# **Observations on “New Build Rigs”**

**Donald Cumming, Equipment Specialist**

**29<sup>th</sup> August 2014**

# Land Rig Mast Accessories

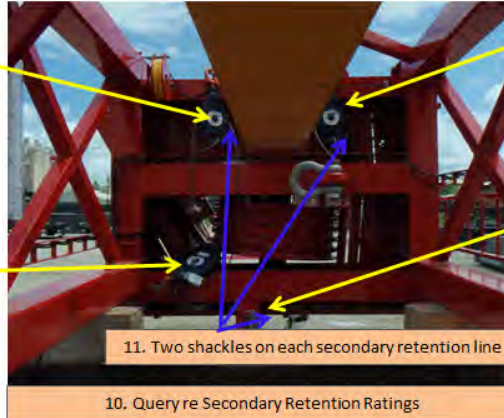
Sheave: M491, 10" TB, 12t (4:1) for 1/2" or 9/16" line.  
 Shackle: 6-1/2 ton  
 Padeye Size / ID: 5MT padeye (MAST046)  
 Dressed with: 1/2" x 175' line type 110-OS-CS, 6x36WS EIP IWRC  
 Serial No.: 1158430-2-1  
 Retention Shackle: WLL 4-3/4 ton & 3-1/4 ton  
 Retention Line: 3/8" x 4'6" type 115-HT-HT, **1.4 ton**  
 Serial No.: 1142192-17-2  
 Retention Padeye Size / ID: **Need to check dims (looks okay)**

Sheave: M491, 14" TB, 12t (4:1) for 5/8" line.  
 Shackle: Pinned across 2 padeyes  
 Padeye Size / ID: 12MT padeye (MAST048)  
 Dressed with: No wire yet.  
 Serial No.:  
 Retention Shackle: **WLL 1-1/2 ton**  
 Retention Line: 3/8" x 4'4" type 115-HT-HT, 1.4 ton  
 Serial No.: 114720-11-1  
 Retention Padeye Size / ID: **Matches 1-1/2 ton shackle**

Sheave: M491, 10" TB, 12t (4:1) for 5/8" line.  
 Shackle: 6-1/2 ton  
 Padeye Size / ID: 5MT padeye (MAST047)  
 Dressed with: 1/2" x 175' line type 110-OS-CS, 6x36WS EIP IWRC  
 Serial No.: 1158430-2-6  
 Retention Shackle: WLL 4-3/4 ton & 3-1/4 ton  
 Retention Line: 3/8" x 5' type 115-HT-HT, 1.4 ton  
 Serial No.: 1158430-1-7  
 Retention Padeye Size / ID: **Need to check dims (looks okay)**

Sheave: M491, 8" TB, 4t (4:1) for 3/8" or 1/2" line.  
 Shackle: 4-3/4 ton  
 Padeye Size / ID: No ID or WLL marked (575?)  
 Dressed with: None  
 Serial No.:  
 Retention Shackle: WLL 4-3/4 ton & 3-1/4 ton  
 Retention Line: 3/8" x 4'4" type 115-HT-HT, 1.4 ton  
 Serial No.: 114720-11-1  
 Retention Padeye Size / ID: **Need to check dims (looks okay)**

The systems are designed with complimenting WLL's, not breaking loads and different SF's can change predicted failure points. Retention systems are rated for the components, not the loads they are rated to carry.

# Fastener Retention

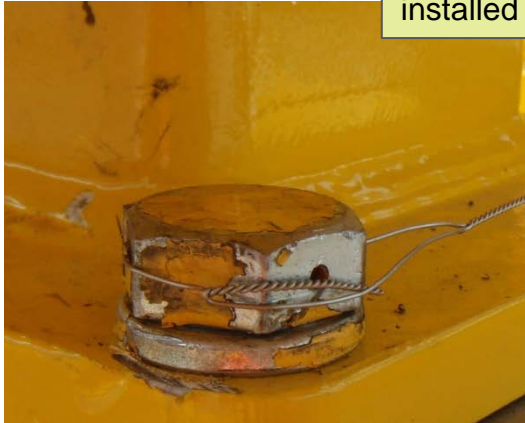
Standard Nordlocks over slots.

Nordlocks on penny washers.

Poor lock installed

Nordlocks installed back to front.

# Nets

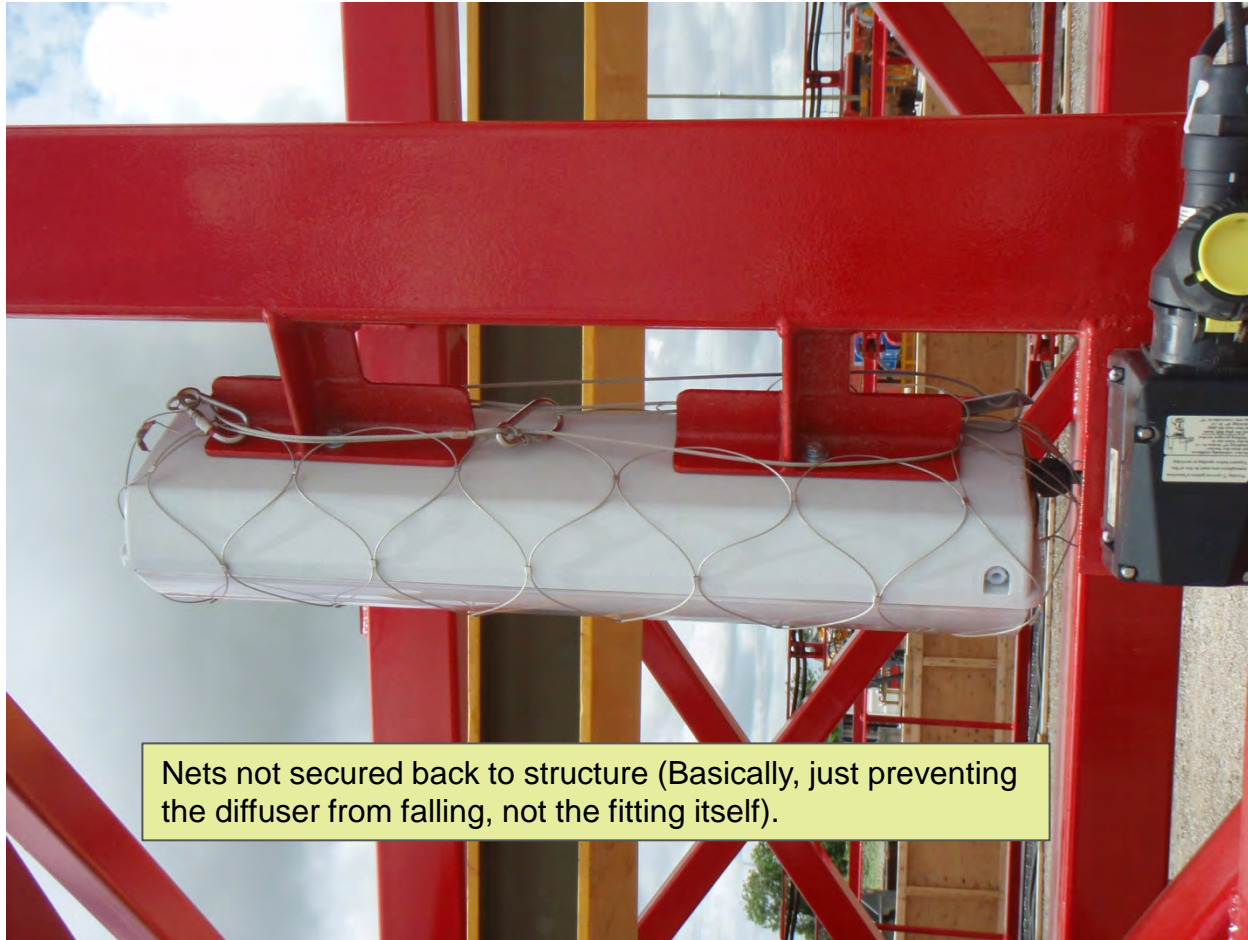
Nets not secured back to structure (Basically, just preventing the diffuser from falling, not the fitting itself).

# Offshore Semi – New Derrick

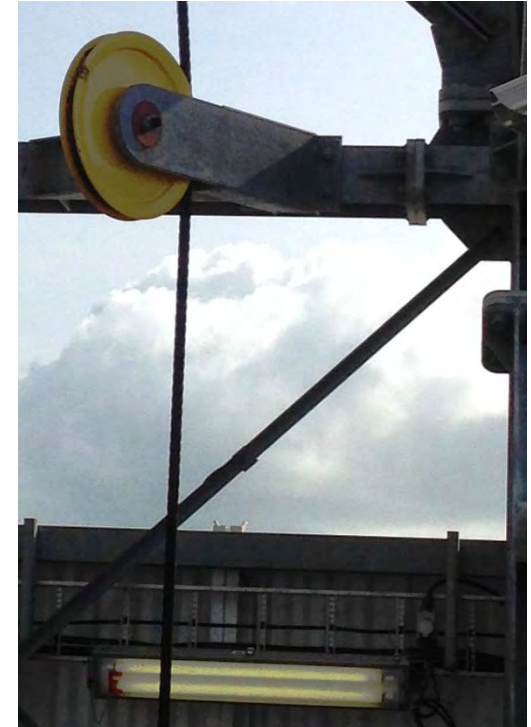
Diverter sheaves on tigger lines above the monkeyboard with no mounting frame, sheave wheel or axle retention.

Fingers with common axle pins, no retention systems.

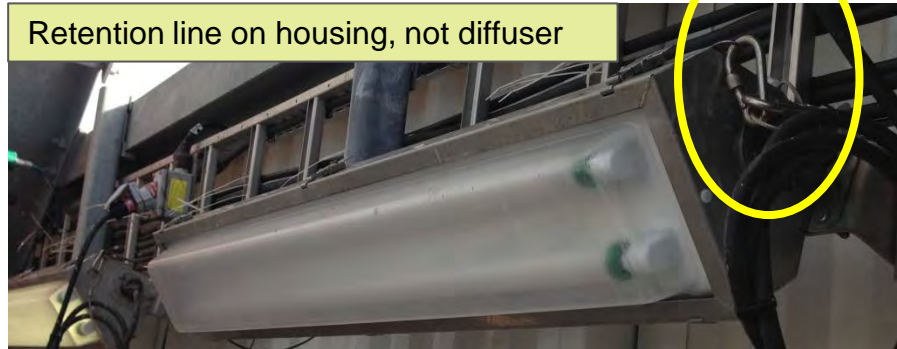
Retention line on housing, not diffuser
